UNITED STATES PATENT AND TRADEMARK OFFICE

APPLICATION NO.	FILING DATE	FIRST NAMED INVENTOR	ATTORNEY DOCKET NO.	CONFIRMATION NO.
09/737,279	12/14/2000	Seiji Hiroshima	MITS:024	7933

Office Action Summary

DETAILED ACTION

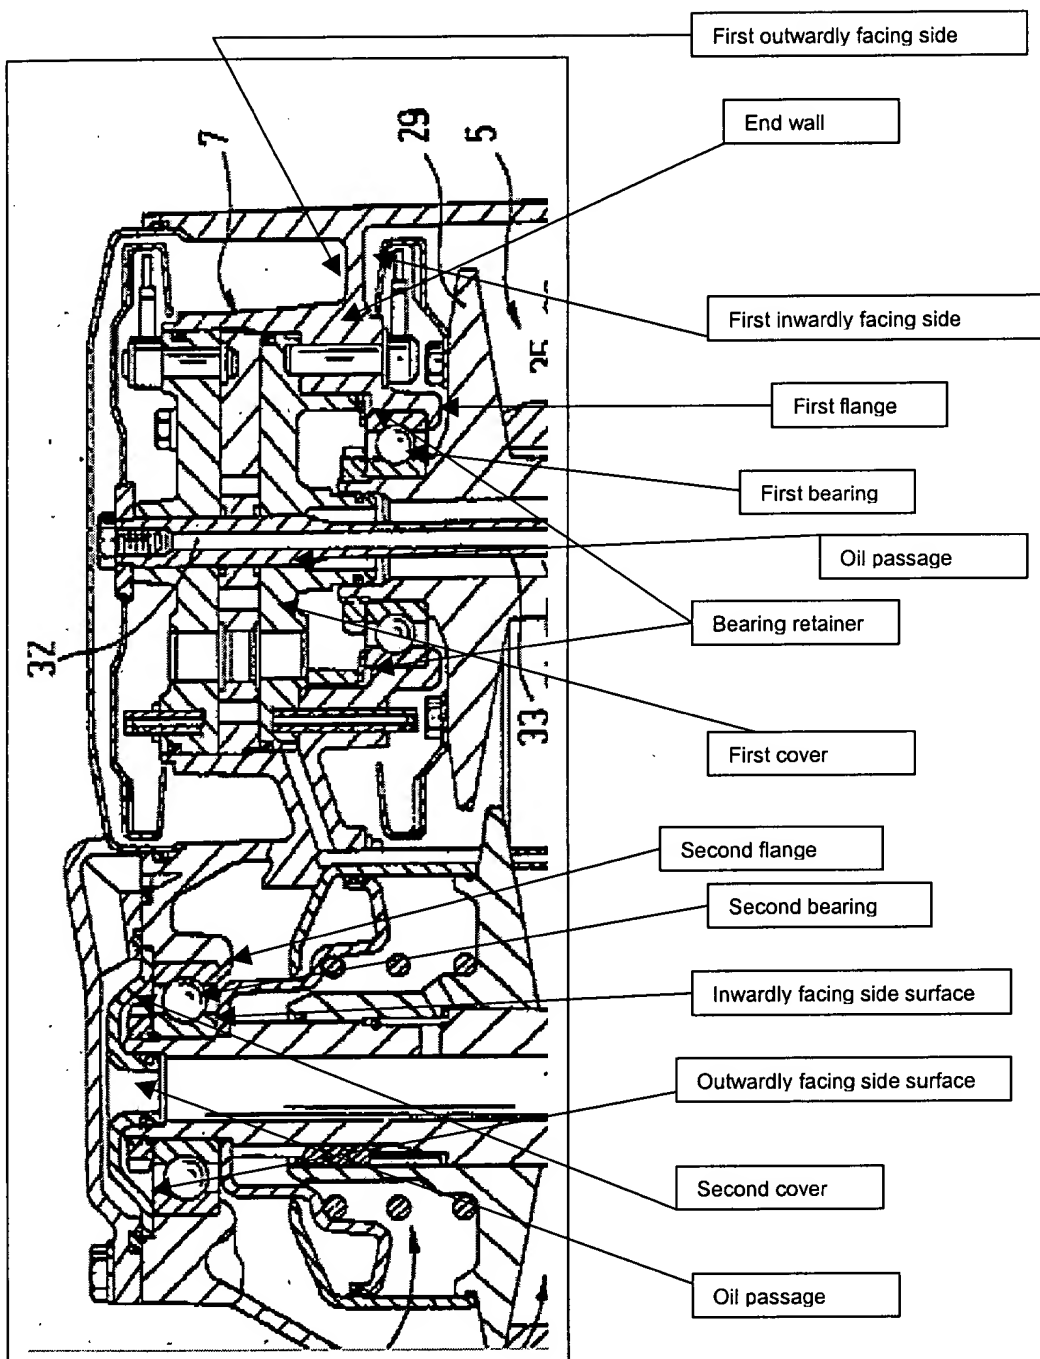
Re: claims 1 and 3. Svab et al. show in the figure a continuously variable transmission comprising : a CVT mechanism comprising: a primary shaft 17 having a primary pulley 5, a secondary shaft shown connected to element 9 having a secondary pulley 9, and an endless belt 36 wound on the primary pulley and the secondary pulley, a housing in the area of the lead arrow of number 7 that accommodates the continuously variable transmission mechanism, the housing having an end wall as labeled on pg. 4 of this Office Action that is formed with a first bearing mounting hole as

shown through which one end portion of one of the primary shaft and the secondary shaft penetrates, the end wall having a first outwardly facing side as labeled and a first inwardly facing side as labeled opposite to the first outwardly facing side around the first bearing mounting hole, the first inwardly facing side being located closer to the primary or secondary pulley associated with the one end portion of the one shaft than the first outwardly facing side, a first bearing as labeled fitted in the first bearing mounting hole and allowing the one shaft to be supported rotatably by the end wall, a first flange as labeled extending radially from the first inwardly facing side toward the first bearing mounting hole, a bearing retainer as labeled provided on the first outwardly facing side of the end wall and projecting radially inwardly toward the first bearing mounting hole, and engaging the first bearing to pinch the first bearing against the first flange as shown, and a first cover as labeled connected to the housing and covering the one end portion of the one shaft and the bearing retainer.

Re: claims 2 and 10. Svab et al. show in the figure the limitation wherein the end wall is formed with a second bearing mounting hole as shown through which one end portion of the other of the primary shaft and the secondary shaft penetrates, the CVT further comprising: a second bearing as labeled on pg. 4 that is fitted to the second bearing mounting hole and allows the other shaft to be supported rotatably by the end wall, an urging member or spring of element 8 that is in contact with (or provided on indirectly), via the element abutting the left side of the spring, an inwardly facing side surface of the second bearing as labeled, the urging member being elastically deformable in an axial direction of the primary shaft and the secondary shaft, and a second cover as labeled that is connected to the housing and covers the one end portion of the other shaft, and cooperates with the urging member to pinch the second bearing in the axial direction.

Re: claims 4-6. Svab et al. show in the figure the limitation wherein the depth of the first bearing mounting hole (particularly the distance between the inside of the first flange and the first outwardly facing side portion of the end wall shown to the right of the top portion of the bearing retainer), which extends in an axial direction of the primary shaft and the secondary shaft, is shorter than the thickness of the first bearing as shown, which extends in the axial direction, and wherein the first bearing receives urging force in a direction from the bearing retainer to the first flange and is thereby in contact with the first flange as shown.

Re: claims 7 and 8. Svab et al. show in the figure the CVT further comprising a second flange as labeled on pg. 4, the end wall having a second outwardly facing side

and a second inwardly facing side opposite to the second outwardly facing side around the second bearing mounting hole, wherein: the second flange extends radially from the second inwardly facing side toward the second bearing mounting hole, the second cover contacts the second outwardly facing side of the end wall and an outer side surface of the second bearing in the same plane as shown; the depth of the second bearing mounting hole, which extends in the axial direction is shorter than the combined thickness of the second bearing and the urging member in a free state, which combined thickness extends in an axial direction, and the second bearing receives urging force in a direction from the urging member (via the element abutting the left side of the spring of element 8) to the second cover and is thereby in contact with the second cover as shown.

Re: claim 9. Svab et al. show in the figure the limitation wherein each of the first and second covers has an oil passage as labeled (Examiner notes that the passages may be considered to be oil passages since element 7 is an oil pump that dispenses oil) through which operation oil is supplied to the CVT (via the unsealed crevices).
